Building Height Dispute Submission: Document Confirmation Request - Fountain Towers
24 messages

Our building, Fountain Towers, located at **7118 Bonita Dr, Miami Beach, FL 33141**, is currently classified as a high-rise. However, in our drawing we fall below the 75-foot height limit as outlined in the code requirements.

WHAT IS A HIGH-RISE BUILDING?

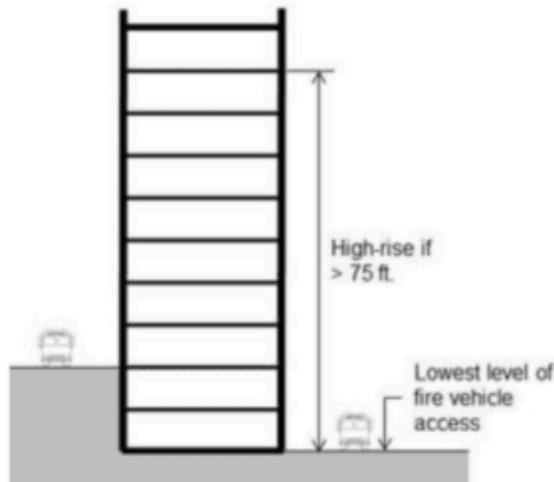
Based on the Florida Building Code a High-Rise Building is defined as "A building with an occupied floor located more than 75 feet (22 860 mm) above the lowest level of fire department vehicle access". If the roof is an occupiable roof such as a summer kitchen, rooftop pool, trellis, etc. then the height includes the roof. The fire sprinklers installation is inspected by our Fire Prevention Department (Captain Bloomfield is copied) to share additional information. An elevation certificate signed and sealed by a Florida Licensed Surveyor verifying the height must be submitted to the Fire Official Mr. Bloomfield and Building Official Mr. Seijas.

Please see the typical measurement information below with unoccupied roofs.

High-rise if > 75 ft.

Lowest level of fire vehicle access
